eCall

**Comments on position measurements
used in draft AECS-02-02-r7**

Example: Chicago Measurements

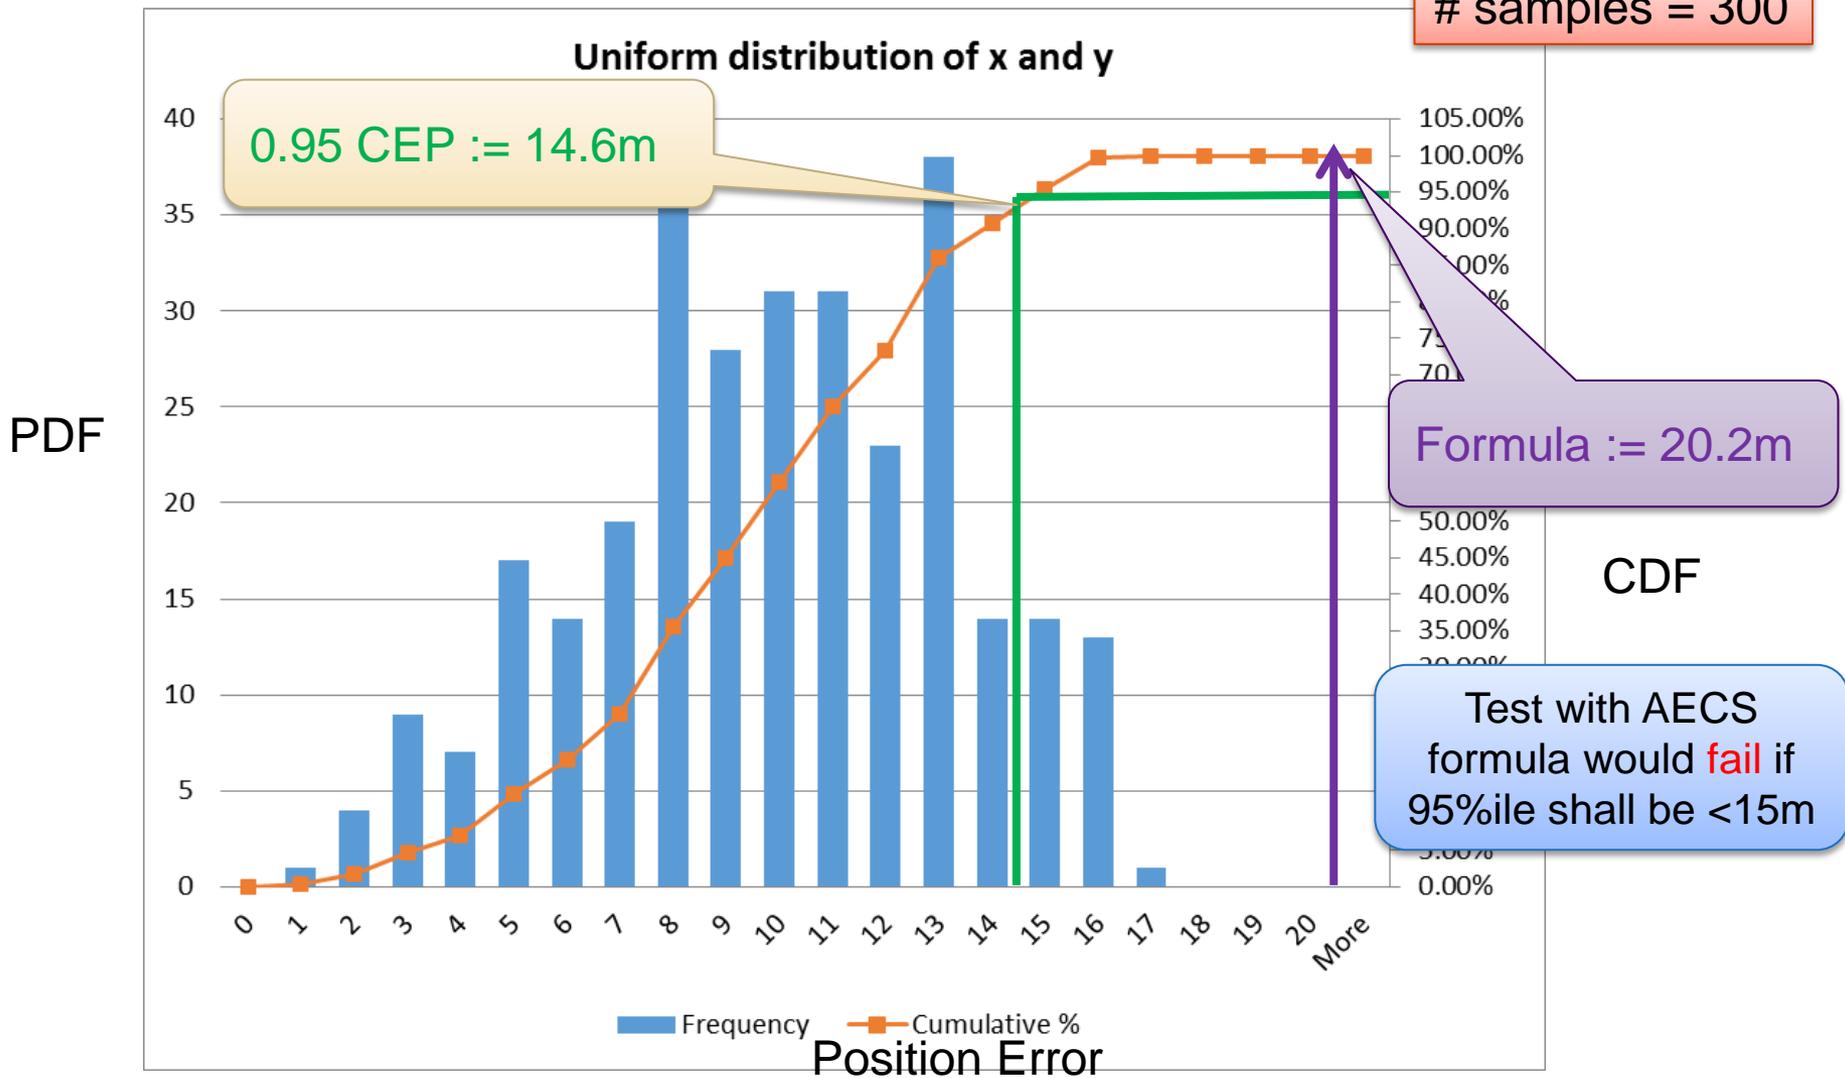
- The formula currently suggested in the AECS draft (Annex 8, Section 3.2.10) to calculate the error probability is assuming a Gaussian distribution of the error, which is not a reasonable assumption
 - The position error distribution depends on the available GNSS constellations, the date of the testing as well as on the environmental conditions around the test area leading to different multipath reflections and shadowing of the GNSS signals
 - Depending on the actual distribution there will be a difference between the currently suggested AECS formula and the desired confidence of 95% percentile
 - The threshold derived from the current AECS formula does not guarantee that 95% of points will be in that error bound.

- Circular Error Probability (CEP) is a well established metric to measure the position error at a given error bound, e.g. CEP is used in mobile communication standards
 - 3GPP TS37.571-1
 - 3GPP2 C.S0036
